ADDENDUM NO.: 1

DATE OF ADDENDUM: 02/28/2013

**New Entry Control Point
Camp Hartell, Windsor Locks, CT
BI – Q – 657**

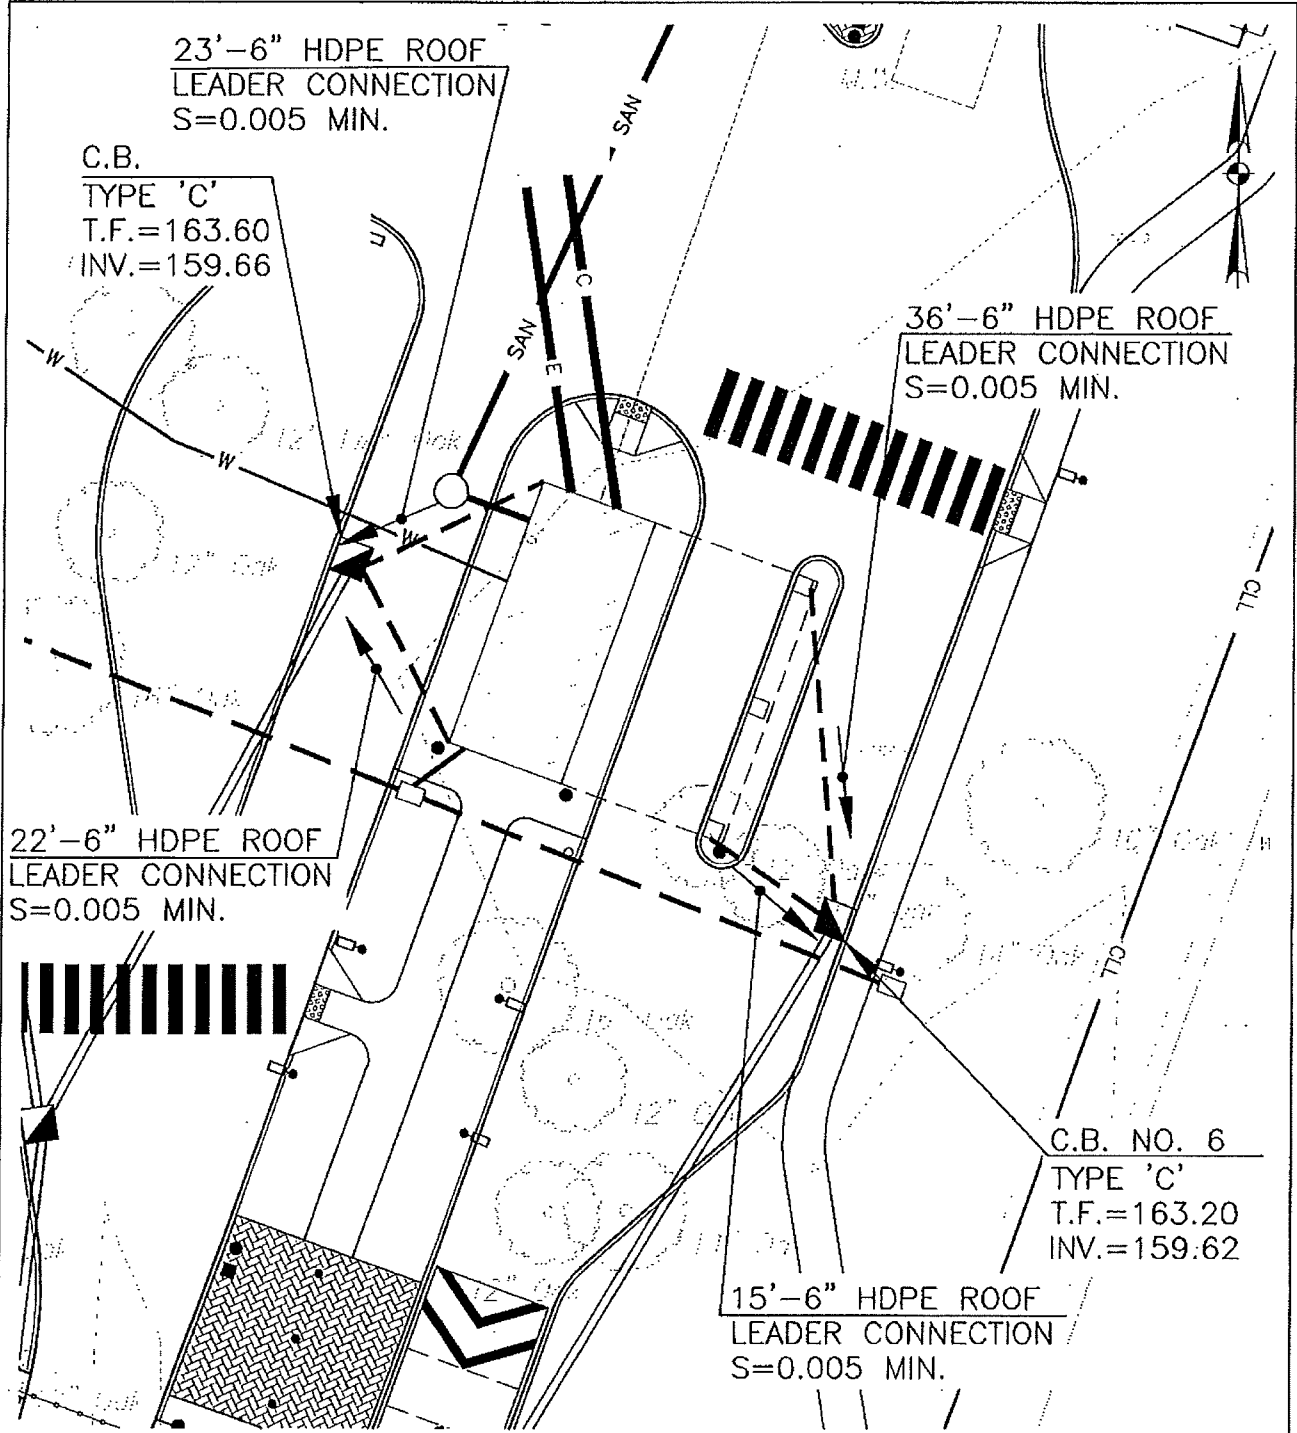
- Q. The details on the guard shack show 4 downspouts and the site drawings show picking up in only 2 locations (q each side), please confirm 4 downspouts or 2 and if 4 will they all be picked up underground?
- A. There are downspouts at the four corners. Please refer to SKC-1 showing the underground pipe layout.
